Project	IEEE 802.16 Broadband Wireless Access Working Group <http://ieee802.org/16>	
Title	Modified LDPC Matrix providing improved performance	
Date Submitted	2004-05-15	
Source(s)	Brian Classon, Yufei Blankenship Motorola	847-576-5675 Brian.Classon@Motorola.com
Re:	802.16e D2	
Abstract	New LDPC matrix providing improves performance for shortened codes	
Purpose	Replace text in previous LDPC proposal: "Draft text for LDPC coding scheme for OFDMA"	
Notice	This document has been prepared to assist IEEE 802.16. It is offered as a basis for discussion and is not binding on the contributing individual(s) or organization(s). The material in this document is subject to change in form and content after further study. The contributor(s) reserve(s) the right to add, amend or withdraw material contained herein.	
Release	The contributor grants a free, irrevocable license to the IEEE to incorporate material contained in this contribution, and any modifications thereof, in the creation of an IEEE Standards publication; to copyright in the IEEE's name any IEEE Standards publication even though it may include portions of this contribution; and at the IEEE's sole discretion to permit others to repro

Figure 1. Block Diagram of one possible encoder for specified LDPC code.

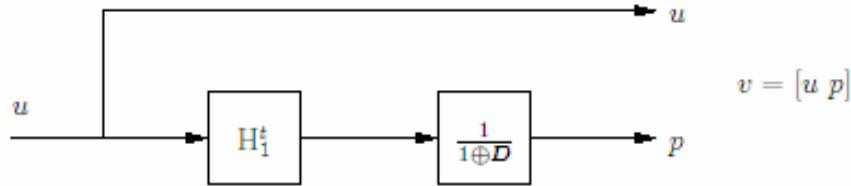
In section 8.4.9.2.4.1 Code Description: delete the text “eighteen edges per check node”

In section 8.4.9.2.4.2 LDPC encoding:

Delete the text:

However, for this code \mathbf{H}_2 is simply $f(D) = 1 + D$, and hence \mathbf{H}_2^{-t} can be implemented by a differential encoder. One possible encoding process is then

and is illustrated in Figure 1.

For the described code \mathbf{H}_1 is low-density, with a uniform column weight of four.

Replace with:

However, for this code \mathbf{H}_2 has a simple deterministic structure, and encoding can be performed recursively. \mathbf{H}_2 is composed of two parts. The weight 3 first column $\mathbf{h} = [h_0, h_1, \dots, h_{m-2}, h_{m-1}]^T = [1 \ 0 \ 0 \ 0 \ 1 \ 0 \ 0 \ 0 \ 1 \ 0 \ \dots \ 0]^T$. The rest of the columns (denoted by the m -by- $(m-1)$ matrix \mathbf{H}'_2 , where $m=n-k$) are weight-2 with maximum of 1 overlap between each other: \mathbf{H}'_2 has matrix elements equal to a 1 for $i=j$ and a 1 for $i=j+1$, and a 0 elsewhere, for row i , column j of \mathbf{H}'_2 , $0 \leq i \leq m-1$, $0 \leq j \leq m-2$.
